Product Change Notification / JAON-14MTDX268

CCB 4492 Initial Notice: Qualification of NSEB as a new assembly site for selected Atmel products available in 28L VQFN (4X4X1mm) package with MSL 1 classification.

CCB 4492
Pre and Post Change Summary
PCN# JAON-14MTDX268

Pre Change ASKR

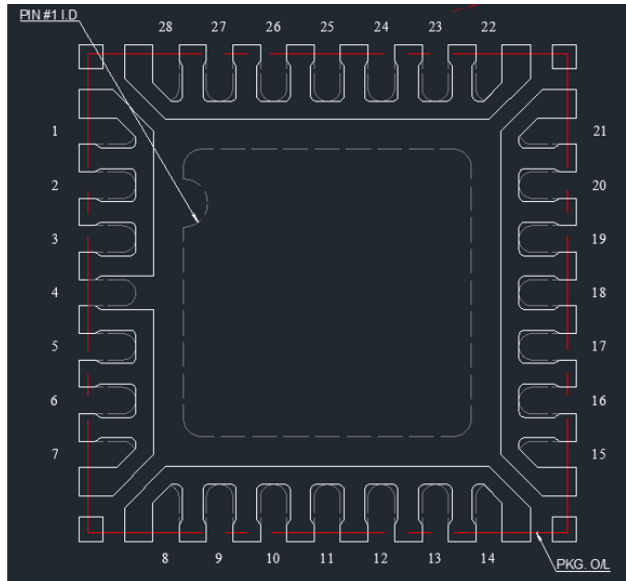
Lead-lock	No
DAP Surface Prep	Ring Plating

Post Change NSEB

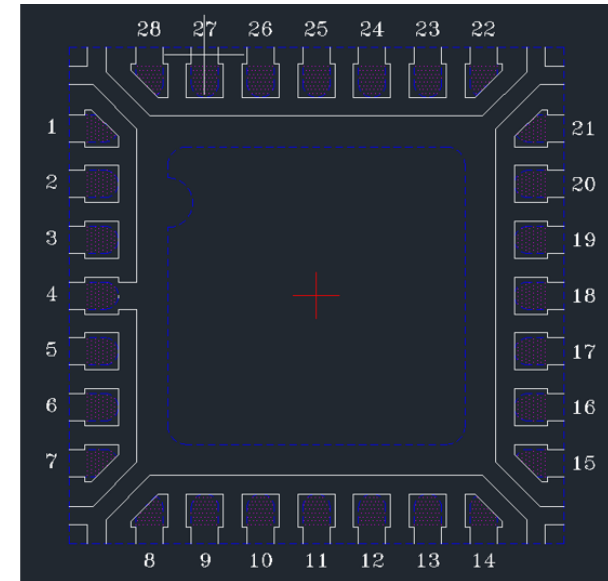
Lead-lock	Yes
DAP Surface Prep	Ag in lead only
